**Re: Passages Warehouse, 6819 Cochiti Rd SE,
Request for Permanent C.O. –Approved
Engineer's Stamp dated: 10-05-11, (K18/D102)
Certification dated: 04-16-12**

Re: Passage Warehouse Addition, 6819 Cochiti SE
Permanent Certificate of Occupancy – Transportation Development
Architect's Stamp dated 10-19-11 (K18-D102)
Certification dated 03-13-12

**Re: Passages Warehouse Addition, 6819 Cochiti Rd SE,
Traffic Circulation Layout ^{K18}
Architect's Stamp dated 09-12-11 (~~K10~~-D102)**

**Re: Passages Warehouse Addition, 6819 Cochiti Rd SE,
Traffic Circulation Layout
Architect's Stamp dated 08-18-11 (K10-D102)**

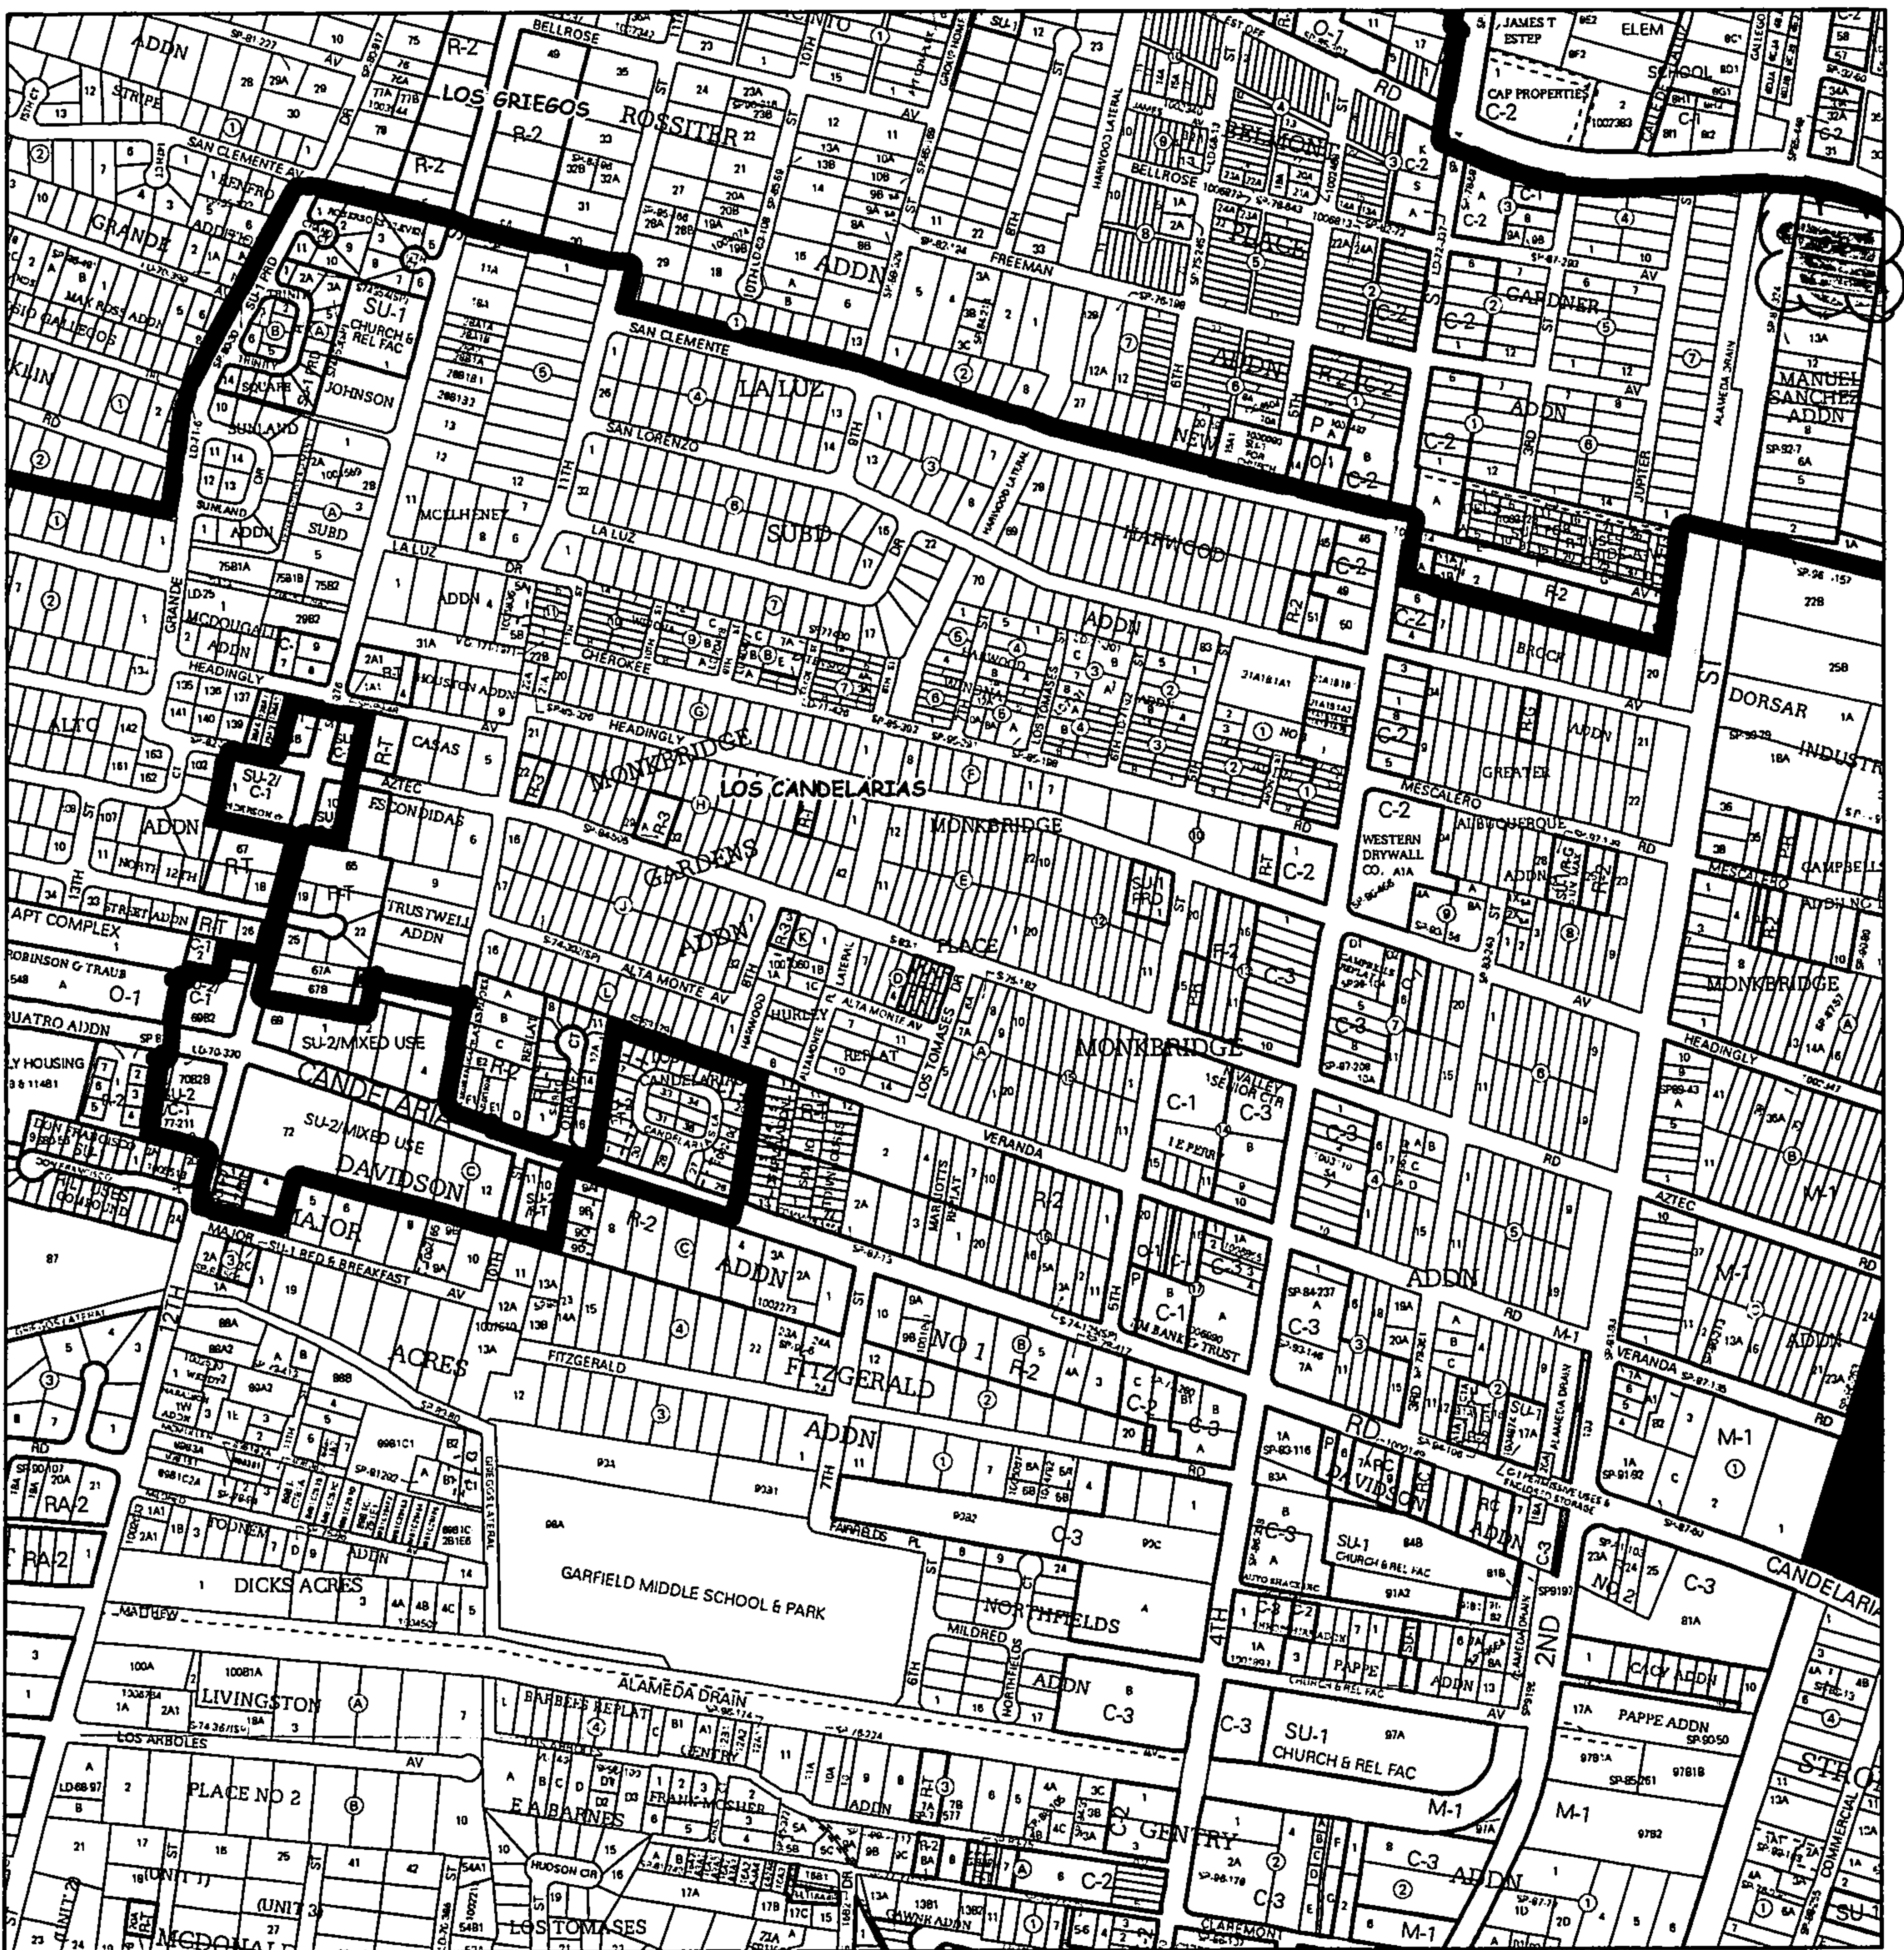
- A basin map is needed for the new building configuration, also showing the AH flood zone at the west end of this site.
- Is there an addition or are you just adding the inlets?
- An SO-19 is required to tie into the existing inlet. Add SO-19 notes to plan.
- It is difficult to confirm your land treatment calculations for this site please adjust your plan accordingly.
- Give elevation points from the surrounding sites.
- Prior to CO, an Elevation Certificate for the existing structure in the AE Flood Zone is required.
- A Floodplain Development Permit is required for the proposed building in the AE Flood Zone.
- Flows must be maintained at or below historic values.
- Provide inlet calculations with a 50% clogging factor.
- Provide the 100 year WSEL.
- Why was this site not built per approved plan dated 6/4/09?
